Work Order ID 95453

Item Name: Crosstube Aft

DART AEROSPACE LTD		Work Order:	95453
Description: Crosstube High Aft (205/212)		Part Number:	D212-664-201
Inspection Dwg: D212-664-241 Rev: D		Page 1 of 1

DRAWING NO. D212-664-241	TITLE CROSSTUBE ASSY (205/212 HI AFT)	REV. D	DART AEROSPACE LTD ENGINEERING ORDER		D.E.O. NO. D212-664-241-D-1	SHEET NO. SHEET 1 OF 2	SCALE NTS
DRAWN	CHECKED	MFG. APPR.	APPROVED	DE APPR.			
DATE 11.04.07	DATE 11.04.11	DATE 11.04.12	DATE 11/04/12	DATE 11.04.12

FIGURE 1: SUPPORT INSTALLATION

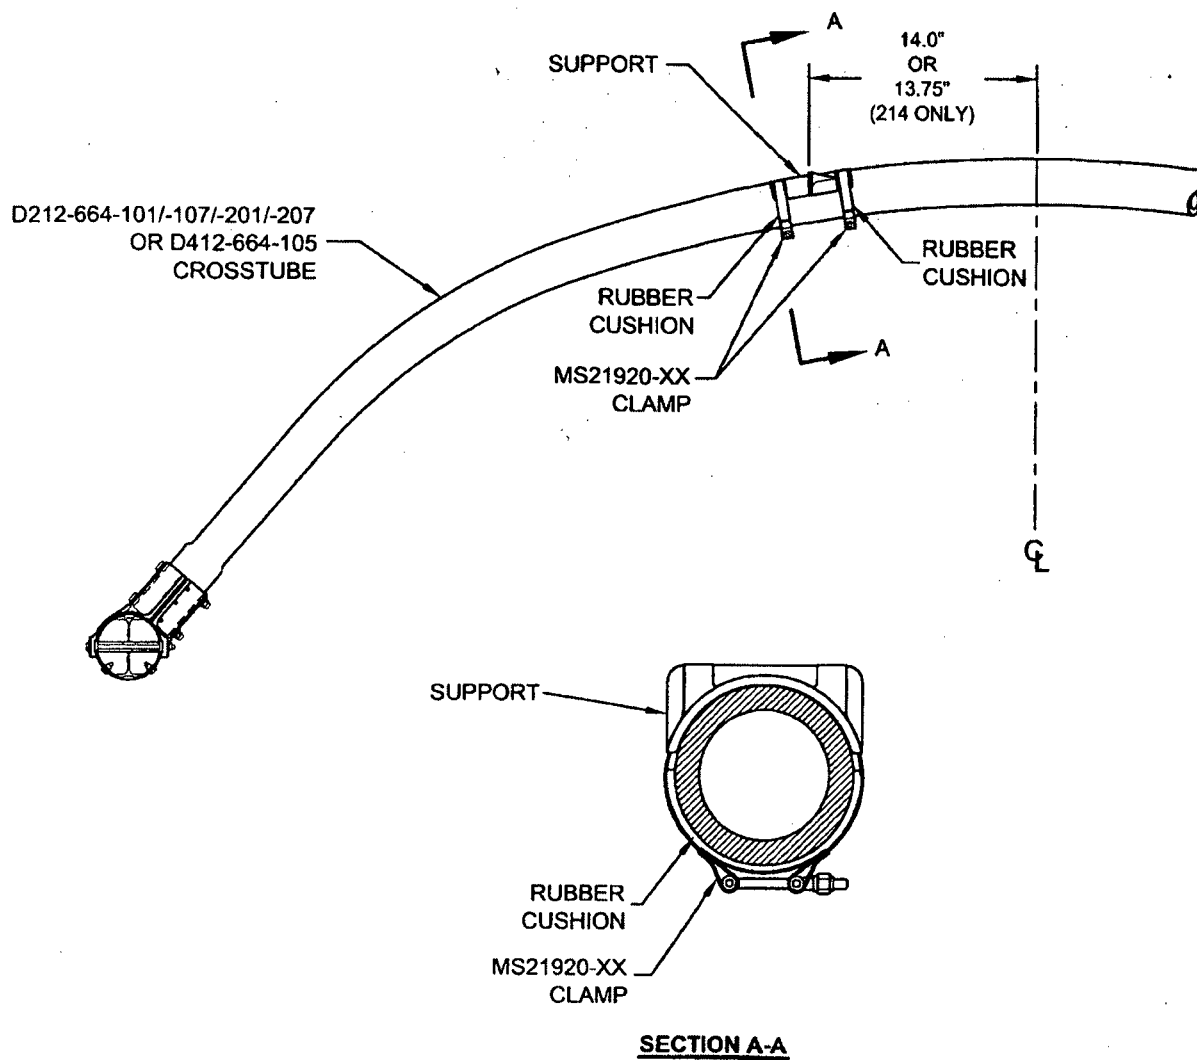
The supports on the following crosstubes are now installed using Proseal instead of Magnobond:

For the crosstubes listed above, section 32.4 of ICA-D212-664 is amended as follows. Use Figure 1 of this service instruction and Figures 32-2 to 32-9 of ICA-D212-664 for further reference. For crosstubes of an earlier change number, it is recommended that if the supports are removed, the supports should be reinstalled using the procedure listed below.

- 32.4.5 Apply a 0.04" to 0.07" thick layer of Proseal 890 Class B or AMS-S-8802 Class B sealant underneath applicable support and install support as shown in Figure 1 of this service instruction.

- 32.4.6 Install the clamps opposite to crosstube support as shown in section A-A of Figure 1. Install rubber cushions underneath each clamp around the bottom circumference of the crosstube up to the crosstube centerline. Torque clamps 80-100 in-lb (9.0-11.3 Nm). It is acceptable to use smaller or larger sized MS21920-XX clamps than those listed in ICA-D212-664, ensure that after torquing the clamps per this instruction, the nuts are in safety but not bottomed out

**D212-664-241/-241B
ASSEMBLY DETAIL**

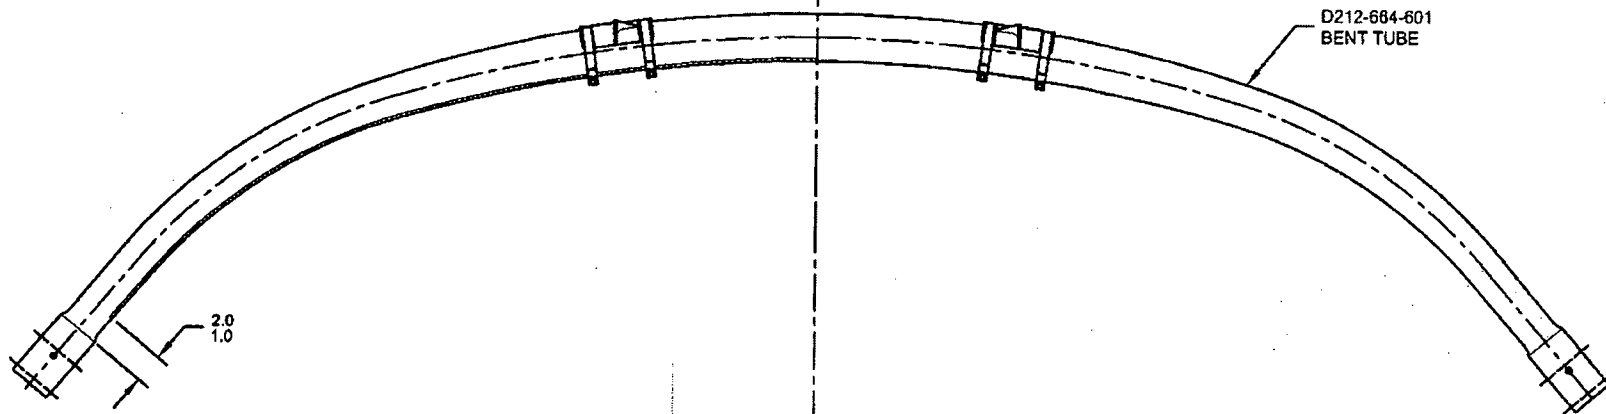
ADD AN INSPECTION WINDOW TO UNDERSIDE OF CROSSTUBE.

NOTES 2 OF SHEET 1 IS AMENDED AS FOLLOWS:

- 2) FINISH: CHEMICAL CONVERSION COAT PER DART QSI 005 4.1
PRIME INSIDE AND OUTSIDE PER DART QSI 005 4.2
MASK UNDERSIDE OF CROSSTUBE AS SHOWN (HATCHED AREA) AND
PAINT OUTSIDE PER DART QSI 005 4.2
REMOVE MASKING AND APPLY CLEAR COAT

MASK AREA PRIOR TO PAINTING,
REMOVE MASKING AFTER PAINT
AND APPLY CLEAR COAT

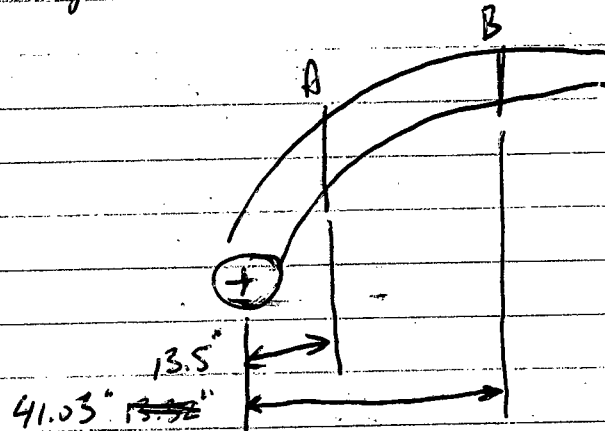
REPLACE MAGNOBOND WITH PROSEAL.

NOTE 12 & 15, SHEET 1 IS AMENDED AS FOLLOWS:

- 12) TO INSTALL D2940-1 SUPPORT: ABRABE MATING SURFACE OF SUPPORT AND CROSSTUBE WITH 180-GRIT SANDPAPER AND REMOVE RESIDUE WITH MEK (OR EQUIVALENT). APPLY A 0.04" TO 0.07" THICK LAYER OF PROSEAL 890 CLASS B-2 (OR AMS-S-8802 CLASS B-2) SEALANT TO MATING SURFACE OF SUPPORT.
- 15) TORQUE CLAMPS 80 TO 100 IN-LB. ENSURE AT LEAST 1.5 THREADS SHOWING IN SAFETY AND THAT NUT HAS NOT BOTTOMED-OUT AFTER TORQUING. **PRIOR TO PACKAGING, RE-CHECK TORQUE ON CLAMPS AFTER PROSEAL 890 SEALANT HAS CURED FOR 72 HOURS.**

CRUSHING OF D212-664-201

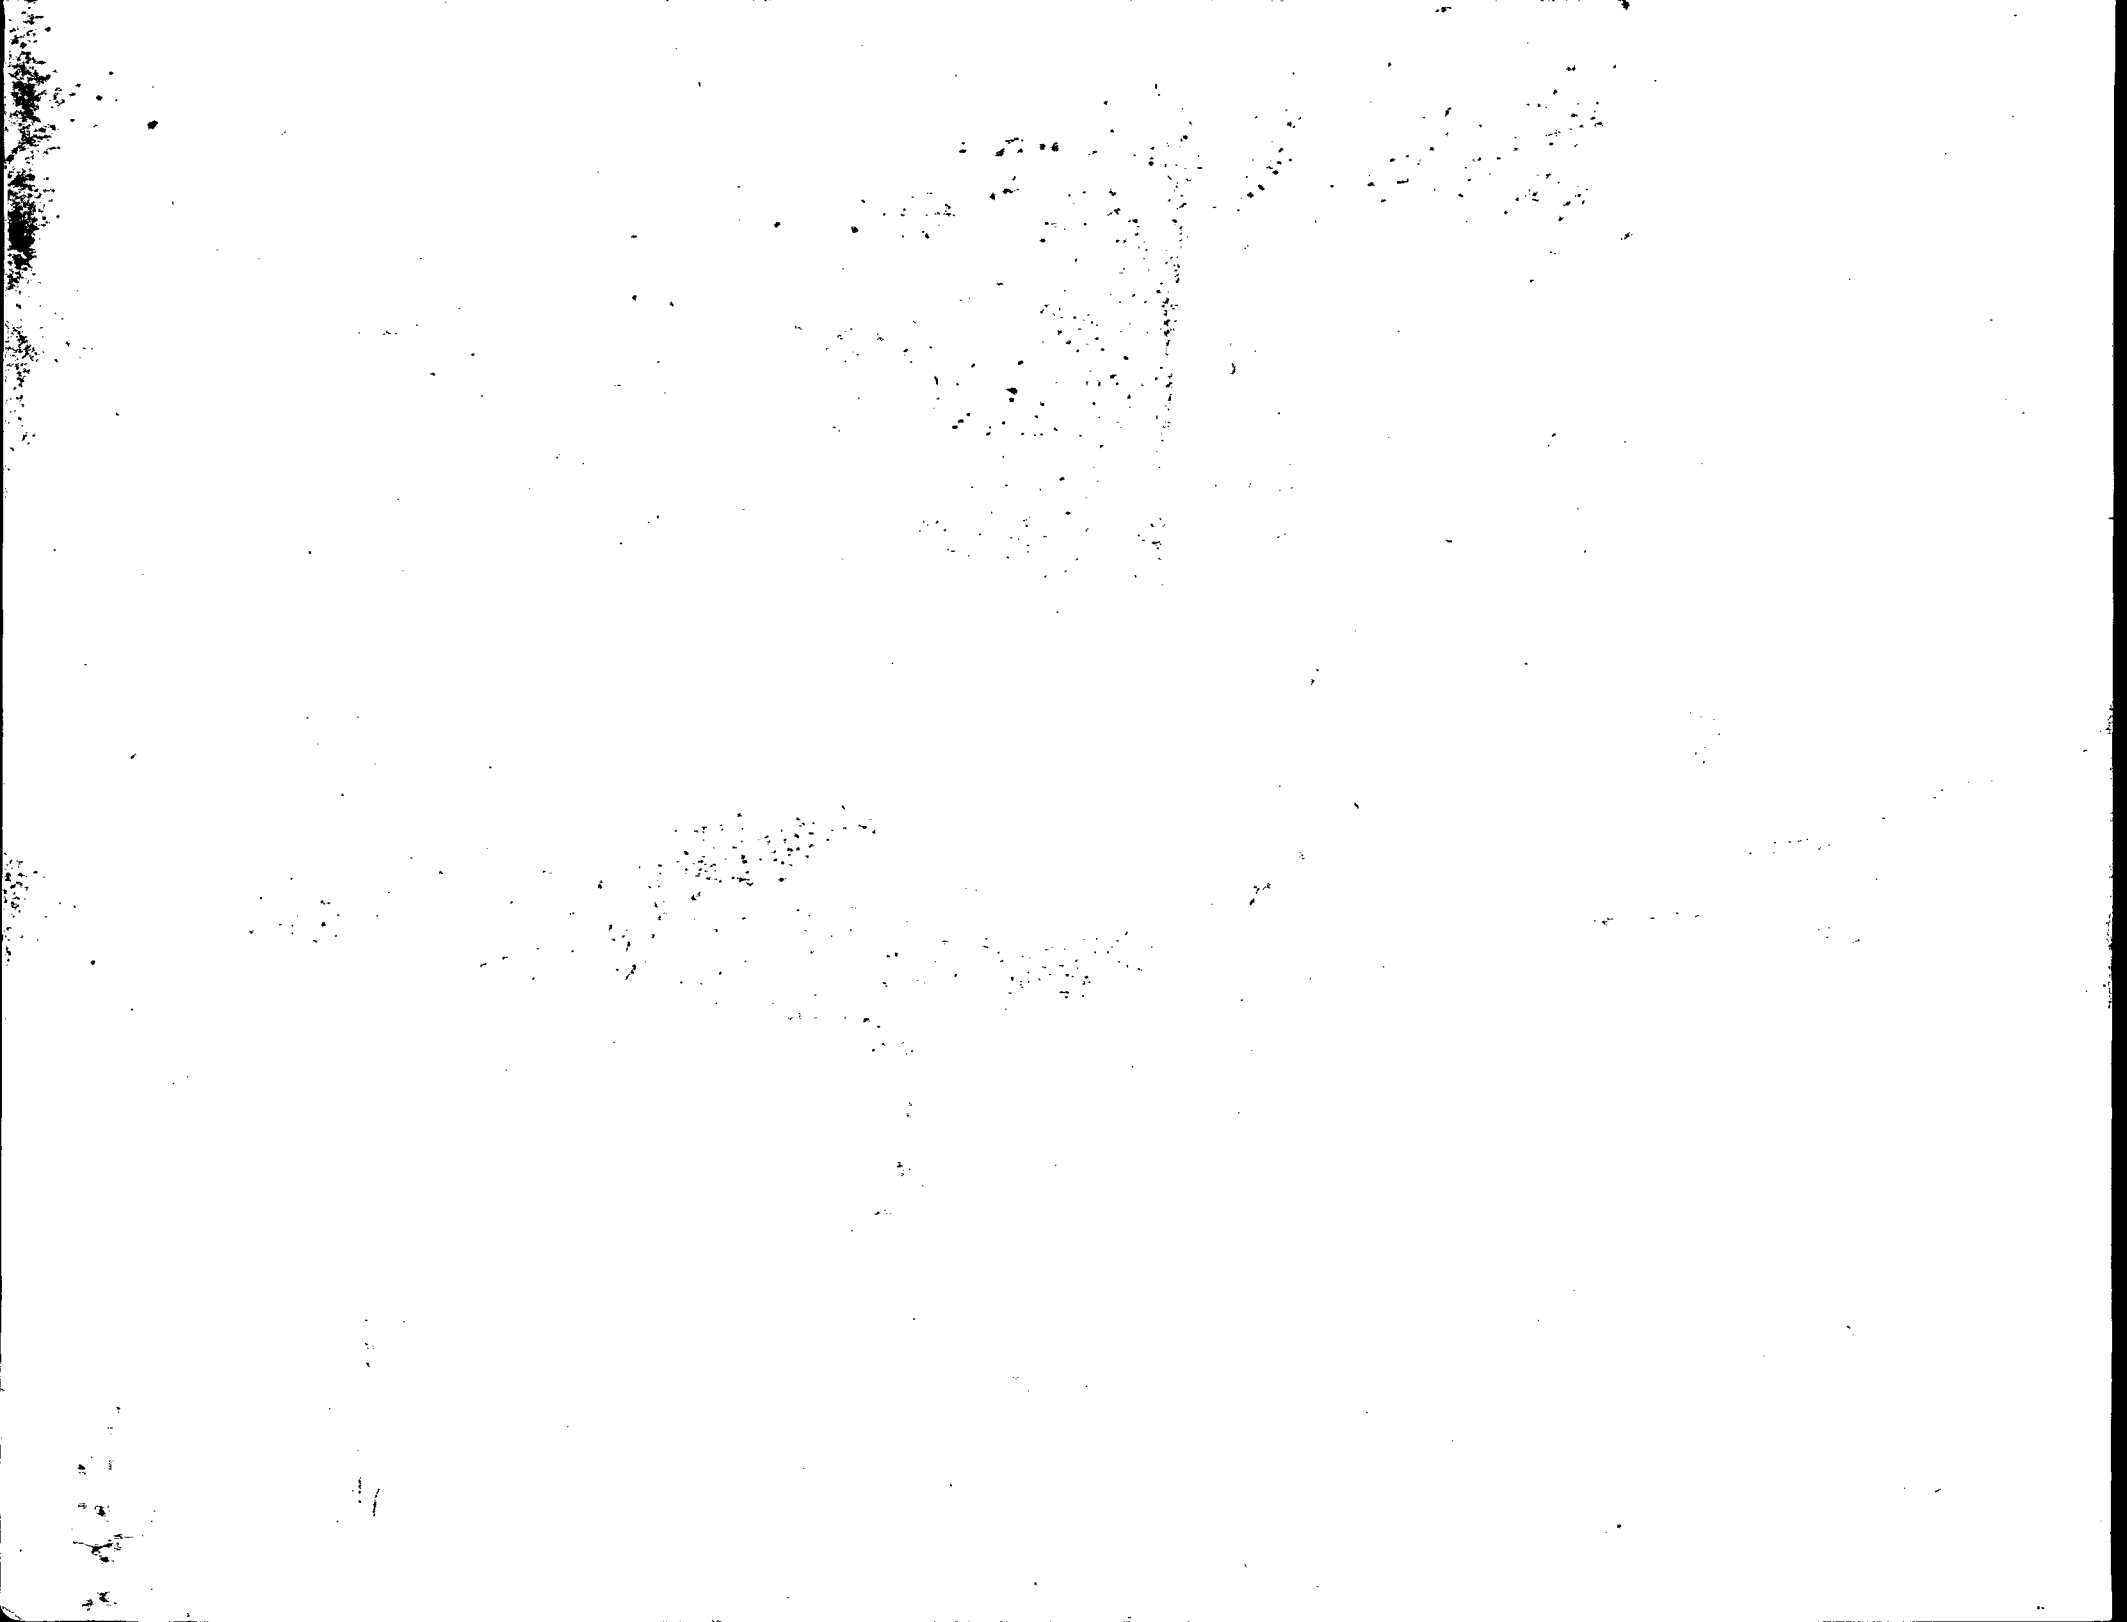
Acceptability of 8% CRUSHING

Point A: $OD1 = 2.548 \text{ in}$ $OD2 = 2.992 \text{ in}$
CRUSHING $(2.992 - 2.548) / (2.992 + 2.548) = 8\%$
 $I = 1.476 \text{ in}^4$

A: $F = MC/I = P \times 13.5 \times 2.548 / 2 \times 1.476 = 11.65 P$
B: $= P \times 41.03 \times 2.992 / 2 \times 4.284 = 14.32 P$

$MS = 14.32 / 11.65 - 1 = 0.22$

Tube will fail at support before area of 8%
CRUSHING, 8% CRUSHING AT END OF BEND
IS ACCEPTABLE
